UNITED STATES PATENT AND TRADEMARK OFFICE

APPLICATION NO.	FILING DATE	FIRST NAMED INVENTOR	ATTORNEY DOCKET NO.	CONFIRMATION NO.
10/767,465	01/28/2004	Thomas Foxen	005127.00278	3624
22909	7590	01/25/2006	EXAMINER	
BANNER & WITCOFF, LTD.			KAVANAUGH, JOHN T	
1001 G STREET, N.W.			ART UNIT	
WASHINGTON, DC 20001-4597			PAPER NUMBER

Office Action Summary	Application No.	Applicant(s)	
	10/767,465	FOXEN ET AL.	
	Examiner	Art Unit	
	Ted Kavanaugh	3728

DETAILED ACTION

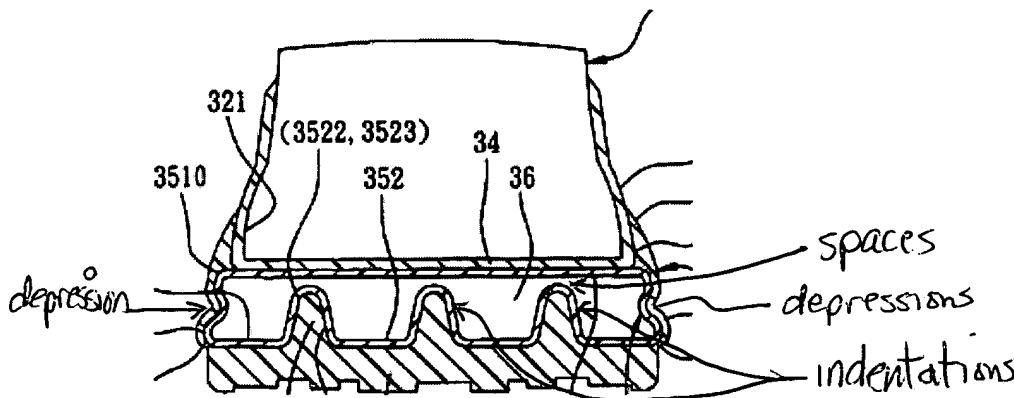
Chi teaches a sole component as claimed including a bladder (36) having a flexion indentation and a reinforcing structure (312) at least partially recessed into the barrier material as claimed. See figure 4 marked-up below.

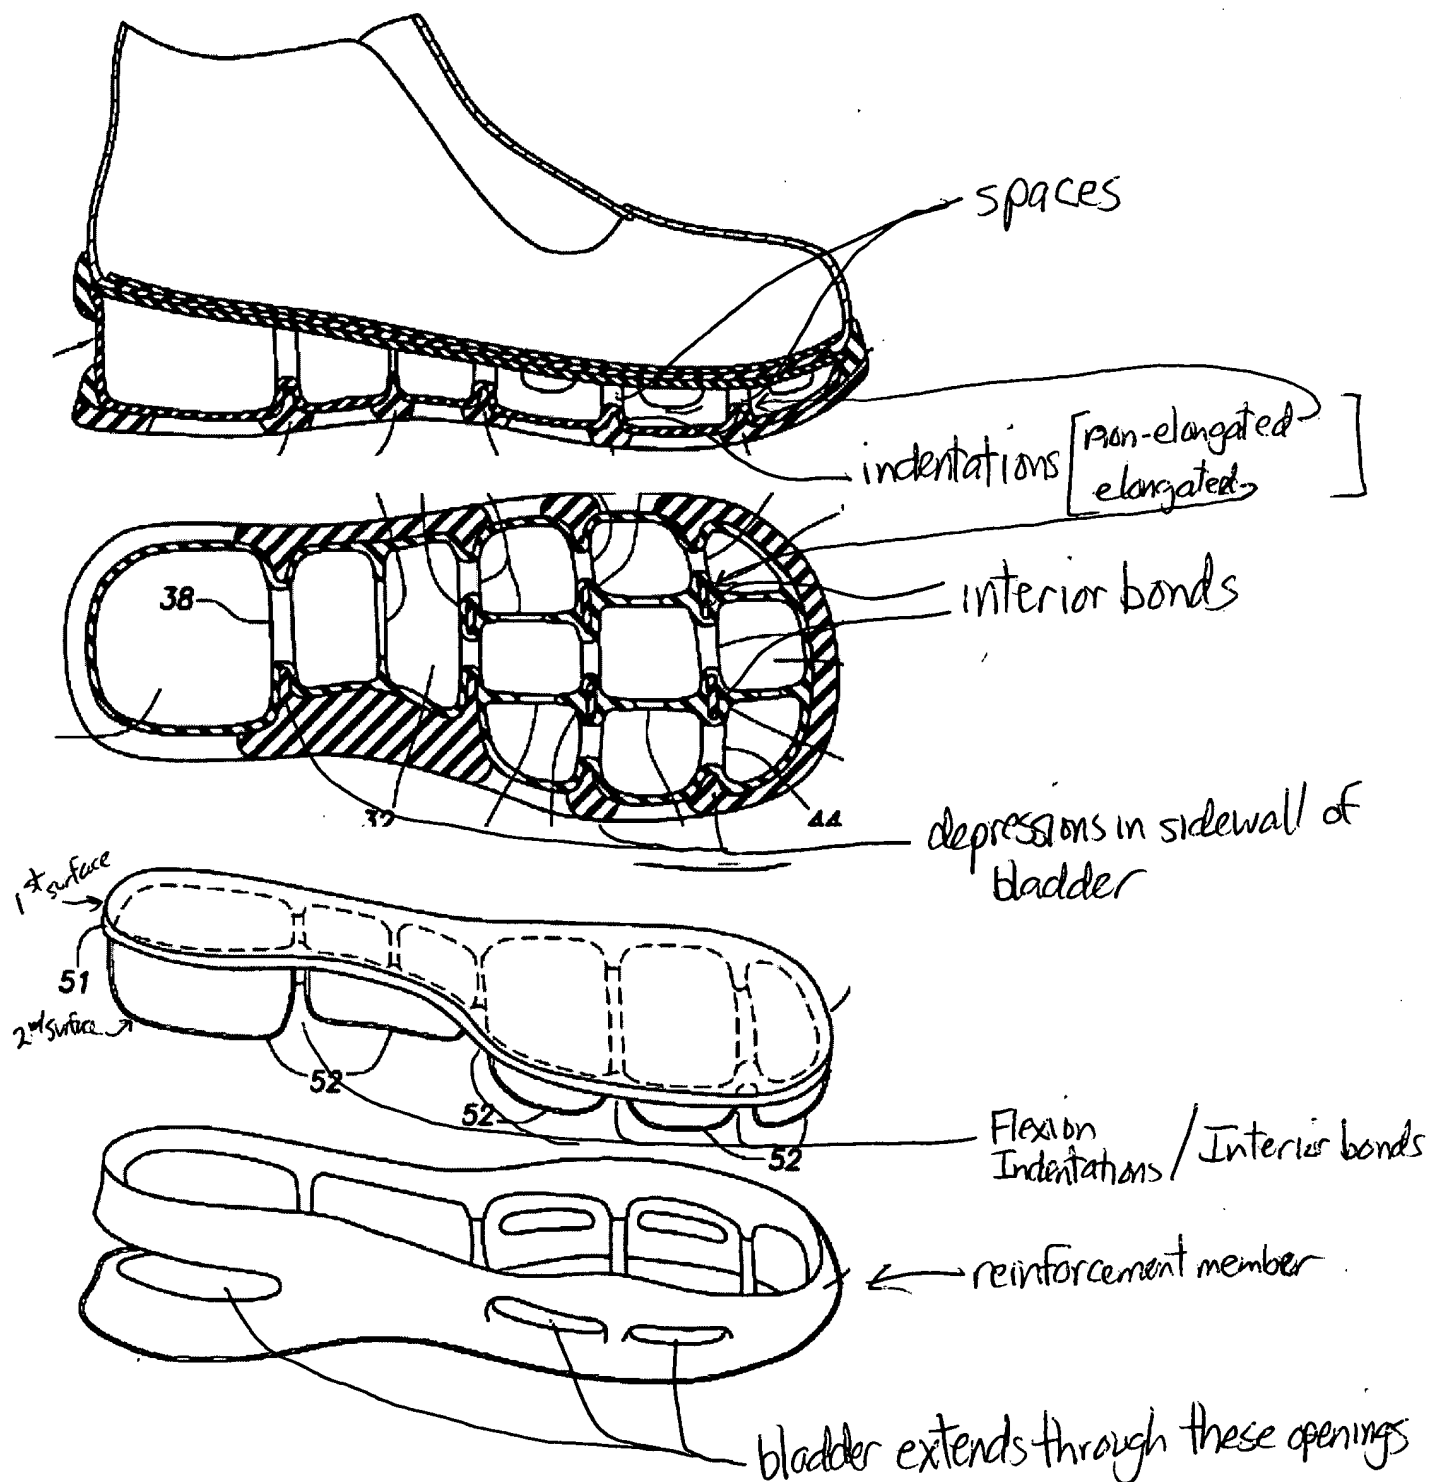
Pavone teaches a sole component as claimed including a bladder having a flexion indentation and a reinforcing structure at least partially recessed into the barrier material as claimed. See the marked-up figures below.

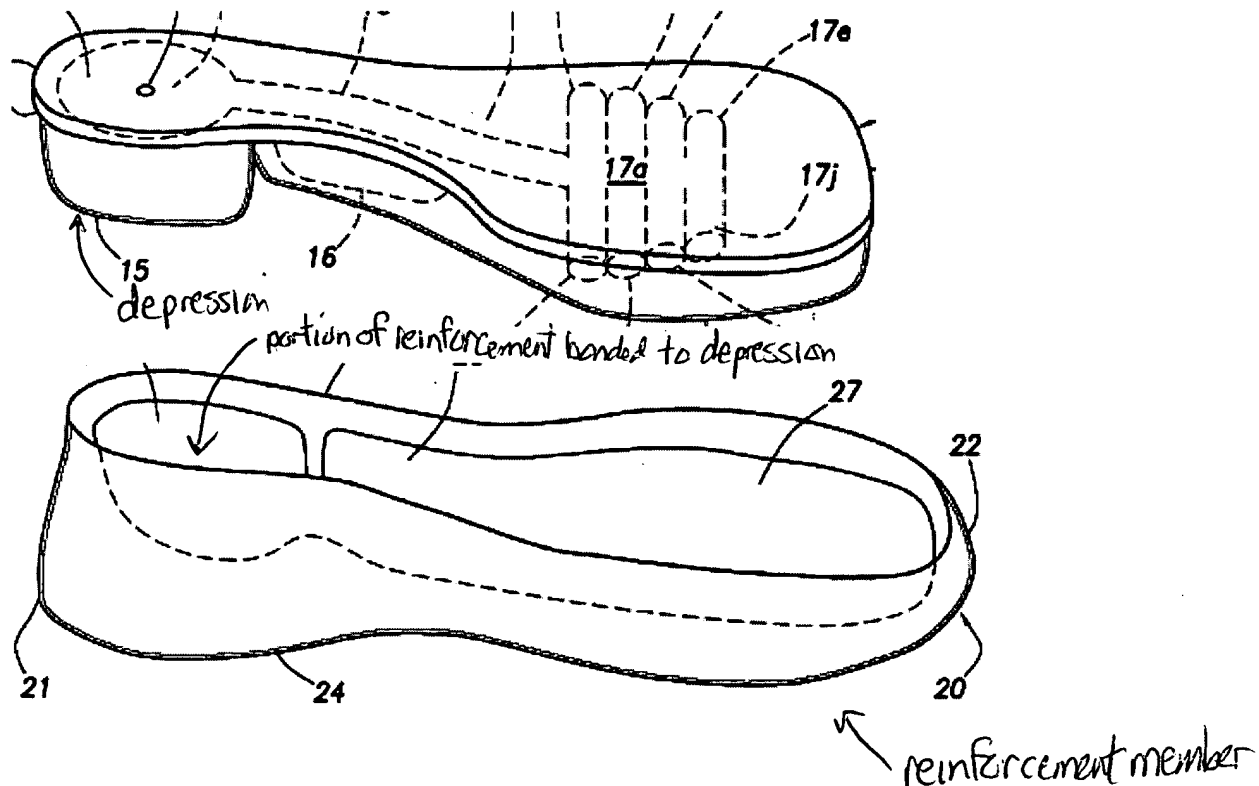
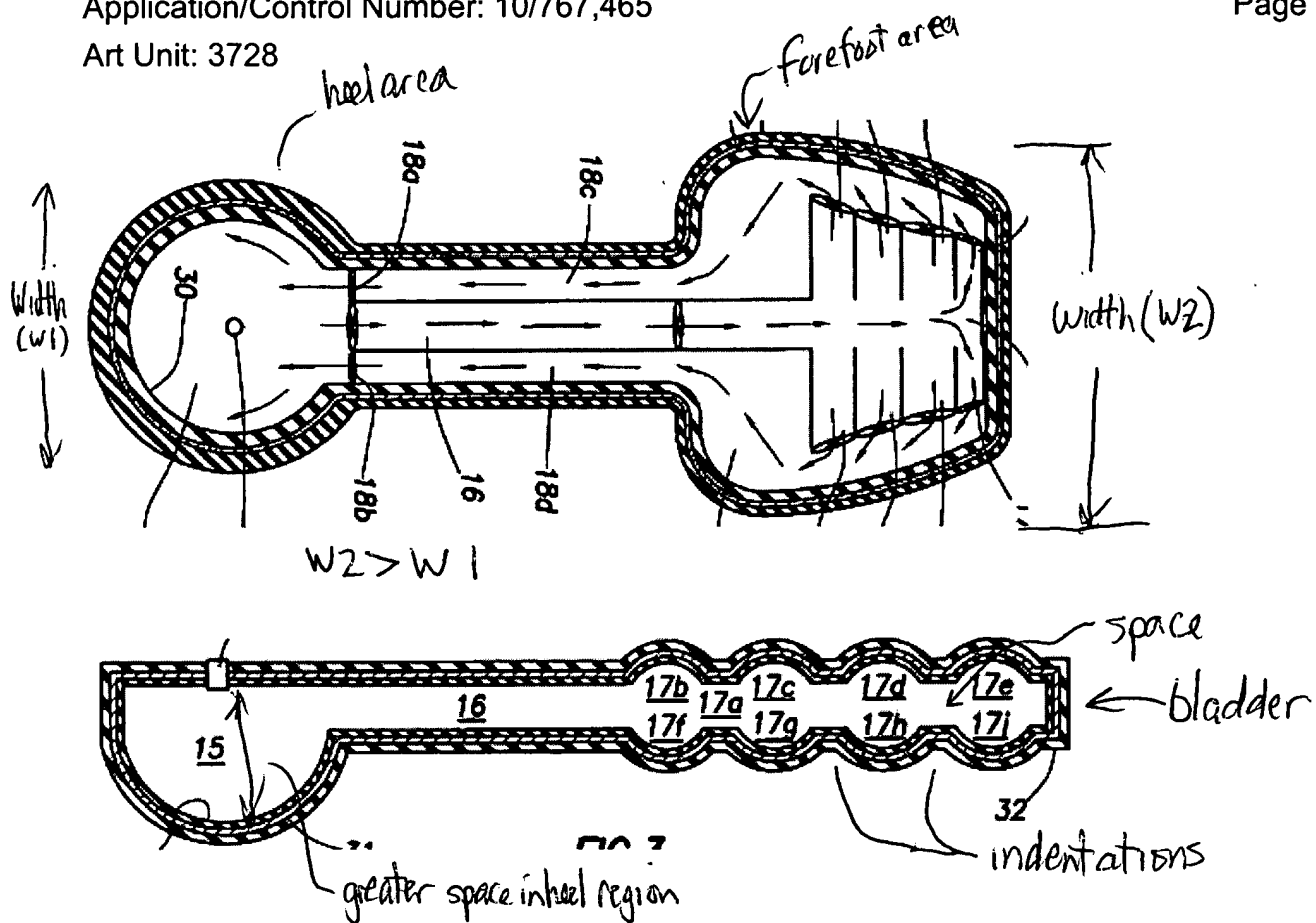
Pavone teaches a sole component as claimed including a bladder having a flexion indentation and a reinforcing structure at least partially recessed into the barrier material as claimed. See the marked-up figures below. Regarding the bladder having two chambers with different pressure, Pavone teaches valves between different chambers in the bladder that regulate the different pressures, see col. 3, lines 29-
